RNP Instrument Approach Procedures at Sherburn-in-Elmet aerodrome

Description of Airspace Change Proposal For ACP-2015-04

March 2022 version

Appendix 3 – CAA questions in November 2021 regarding the September 2021 submission

5.3 VFR chart 1:500,000 scale view Runway 28 approach

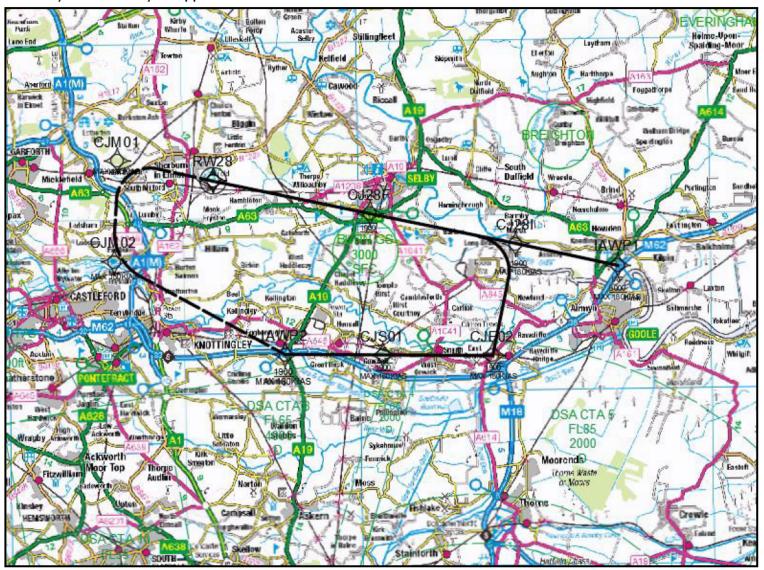
about the wider philosophy of how the IAP will be used.
Page 8	Why is the use of the MAP Path envisaged to be very	Because the vast majority of approaches result in a landing rather than
	limited?	a missed approach. Exact figures for GA are not available, but a typical
		missed approach rate would be in excess of 1 per 100 approaches
		based on typical pilot experience.
Page 8	Burn is a potential hazard; the risks will be addressed as	Noted.
	part of the operational procedures for the IAP; IFP	
	Regulator to check.	
Page 10	Procedure will still go 100ft below Doncaster CTA; is	Yes.
	this considered safe?
